LATHAN • McKEE ARCHITECTS

ADDENDUM NO. 2
NEW CLASSROOM ADDITION FOR ASHVILLE HIGH SCHOOL
Architect Job No. 24-106
August 26, 2025
DCM #20240625

The Plans and Specifications are hereby amended. The following supersedes all contrary and/or conflicting information and is made part of the contract documents.

JOBNO.	24-106
SHEET NO:	P0.1
0	1" = 2'

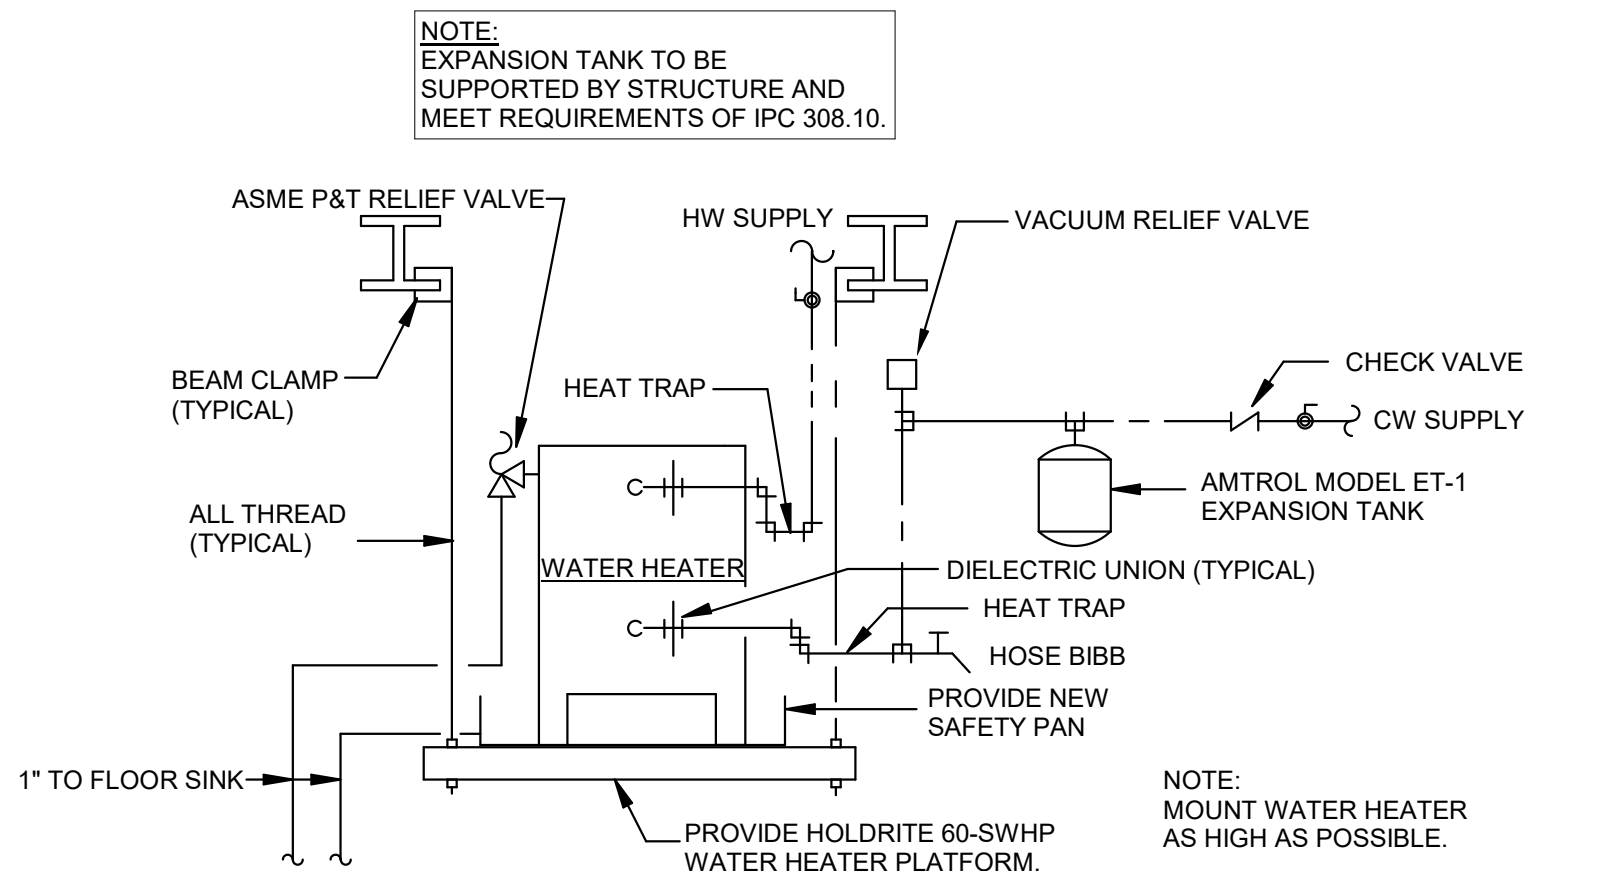
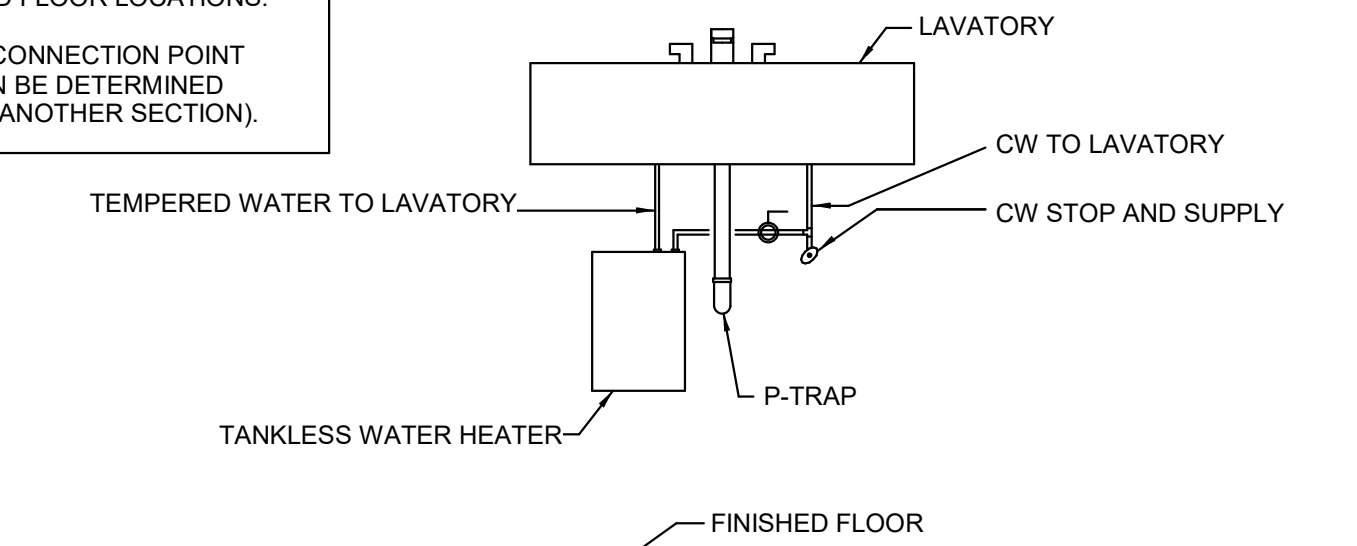
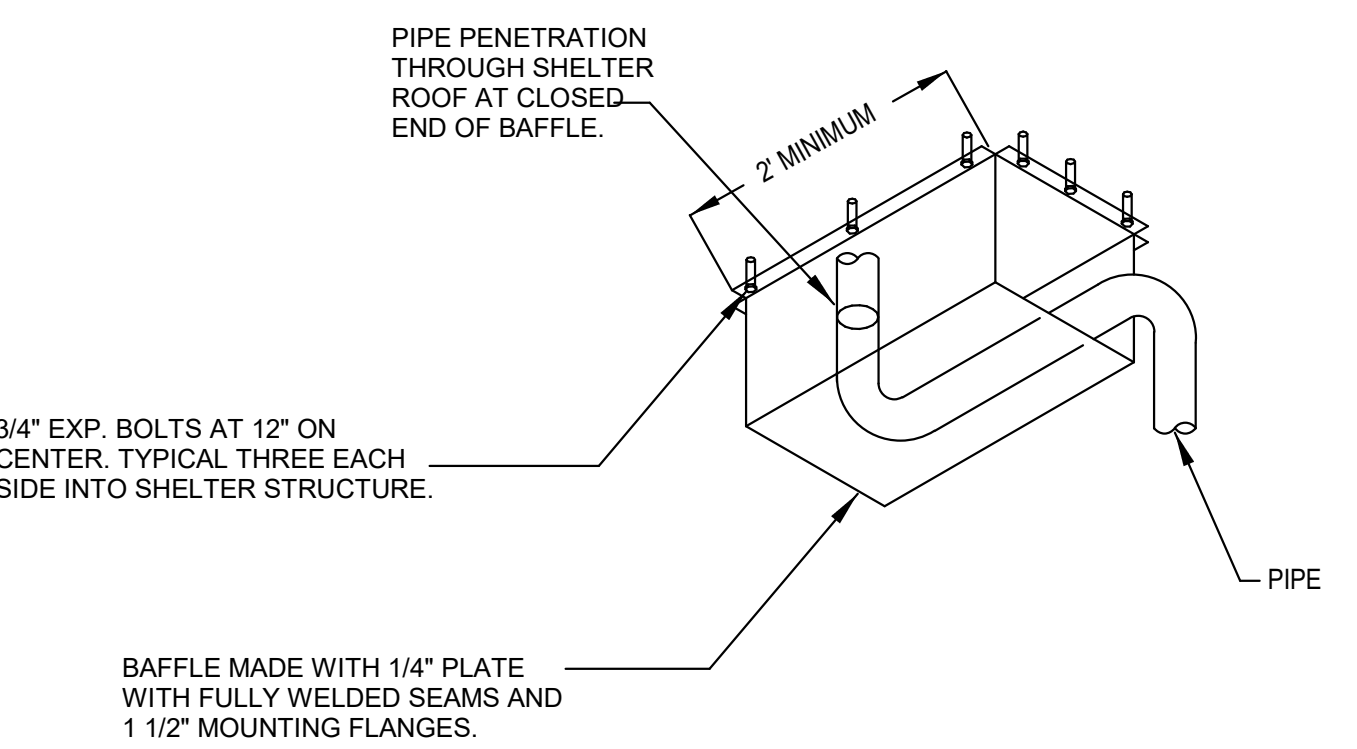
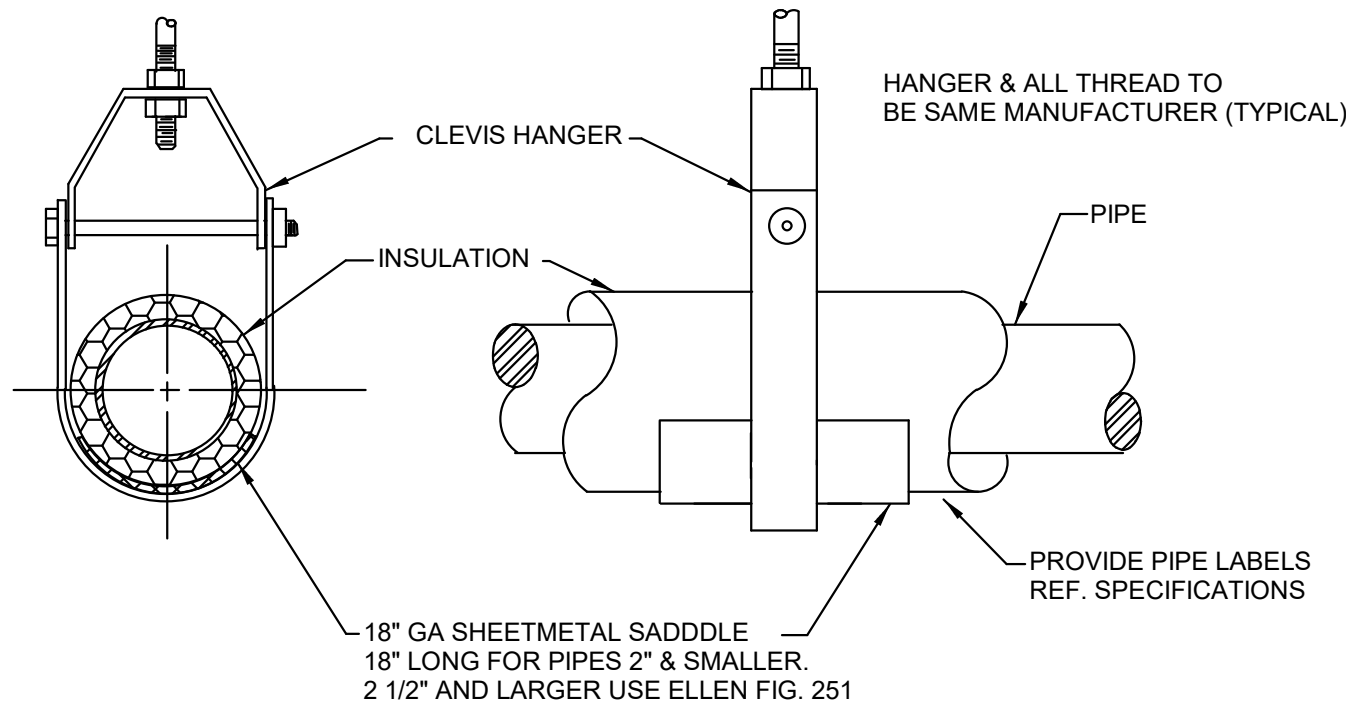
1. **SHEET P0.1 – PLUMBING – SCHEDULES, DETAILS, & NOTES:**
 - a. Revised to add the gas valve mark used on the plumbing plans to the Lab Fixture Schedule.
2. **SHEET P3.0 – PRESSURE – RENOVATION FLOOR PLAN:**
 - a. Revised to include a gas piping riser diagram.
3. **SHEET M0.2 – MECHANICAL – DETAILS:**
 - a. Revised Fire Damper Installation Detail to show access door size.
4. **SHEET M2.1 – HVAC – RENOVATION FLOOR PLAN:**
 - a. Revised to add fire damper.
5. **SHEET S1.0 – GENERAL NOTES:**
 - a. Updated General Notes for Aggregate Piers.
6. **SHEET S2.1 – FOUNDATION PLAN:**
 - a. Updated footing step locations for Storm Drain.
7. **SHEET S3.1 – SECTIONS AND DETAILS:**
 - a. Updated Detail #3 to include 8" and 12" CMU.
